**INDUSTRIAL DRIVE ATHLETIC FIELDS AND
DAWSON RECREATION IMPROVEMENTS
HOLDEN, MA**

ADDENDUM NO. 3

March 1, 2024

SKL-01

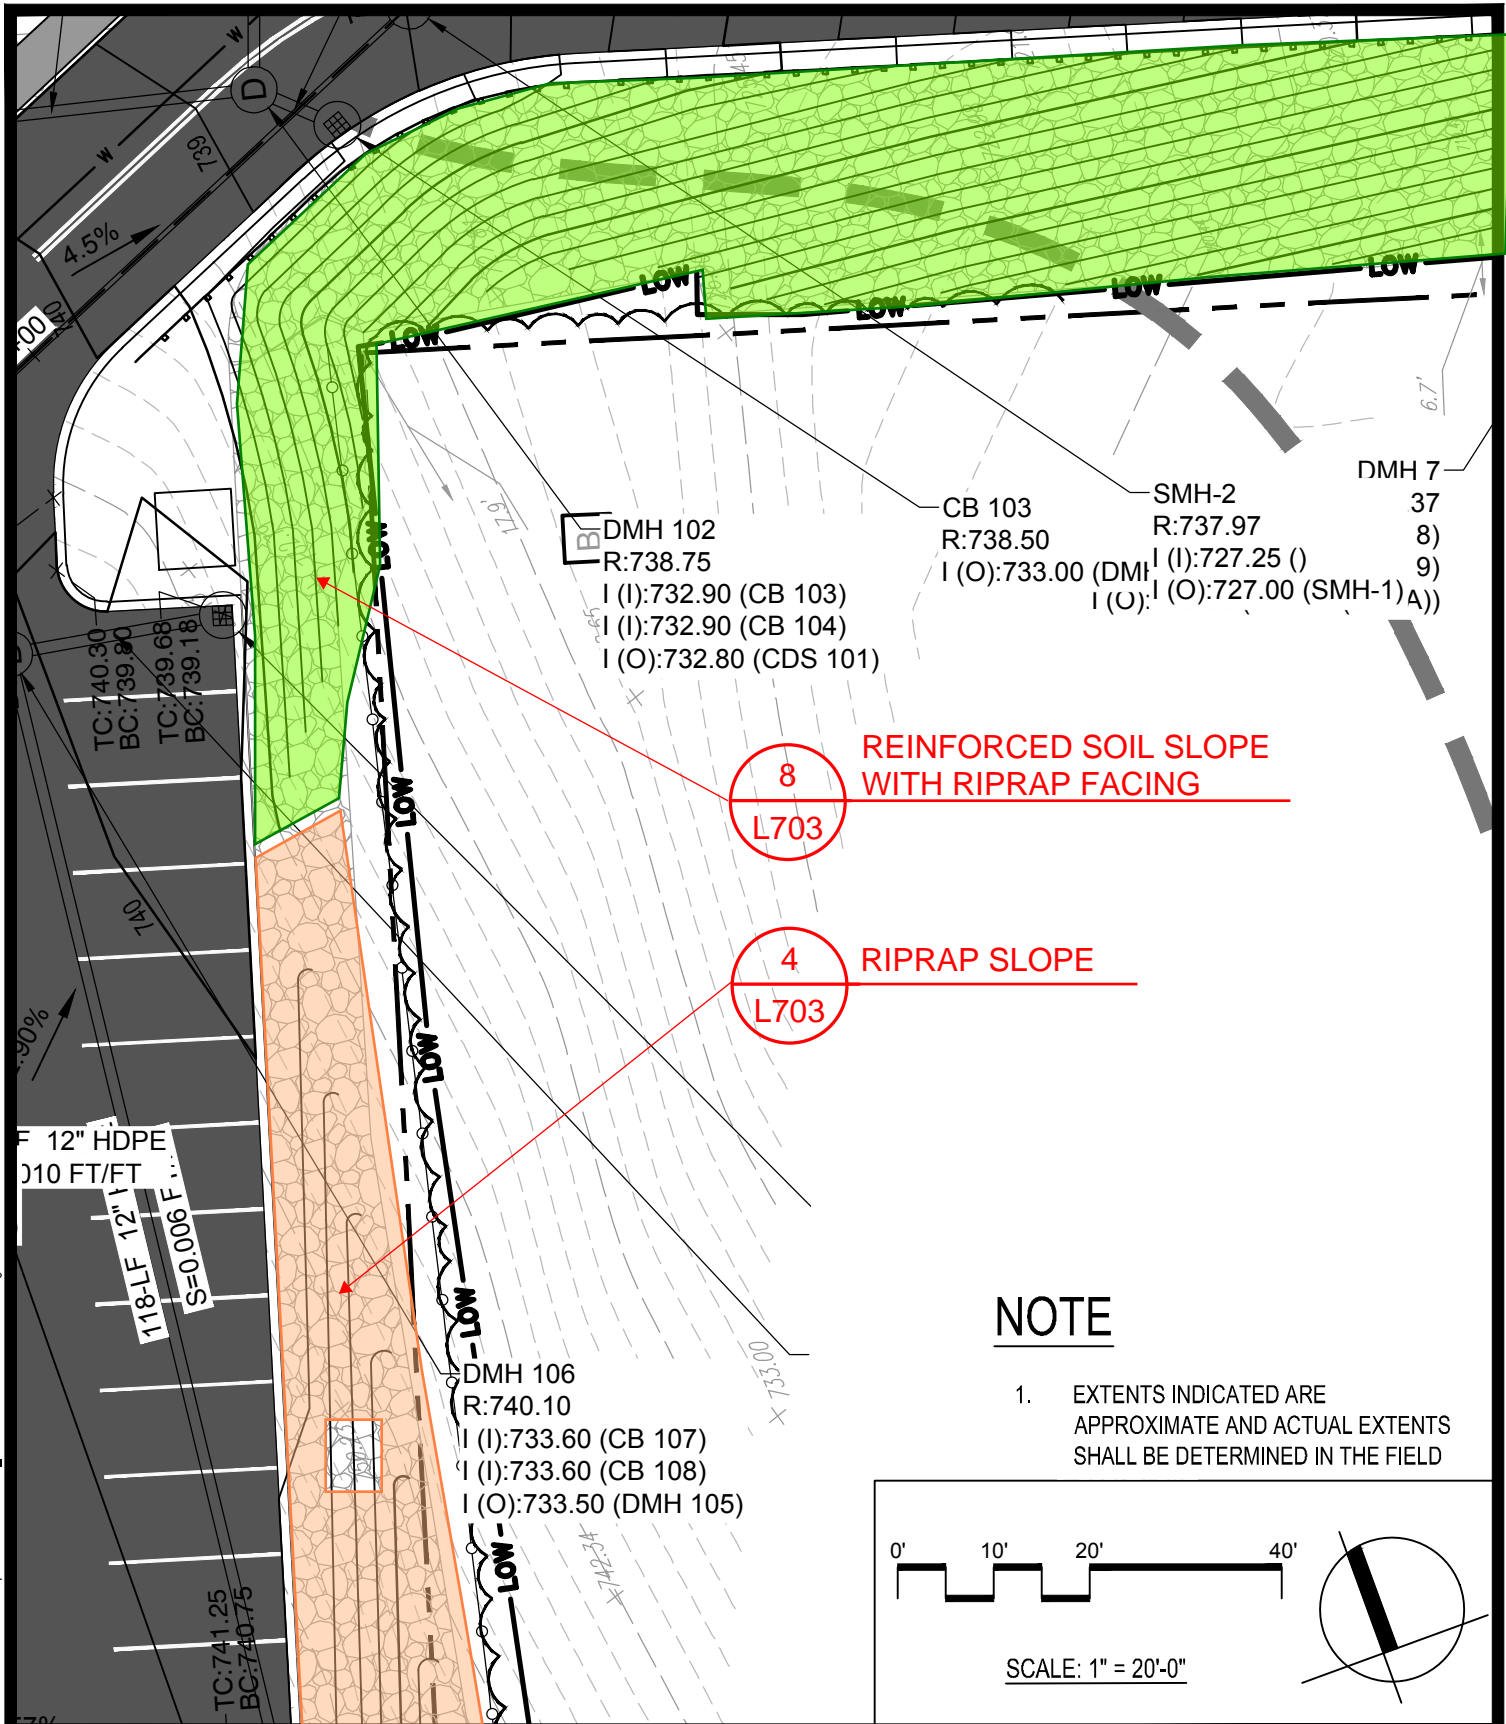
Question 5: *Sheet L301 calls out detail 4/L703 for the rip rap slope along the parking lot. It's unclear what the limits of this condition are and when it transitions to detail 8/L703 which is called out along the entrance drive on L300.*

Response: Refer to limits of condition of riprap slope at parking lot per SKL-1: RIPRAP SLOPE LOCATIONS APPROXIMATE LOCATIONS, per attachment.
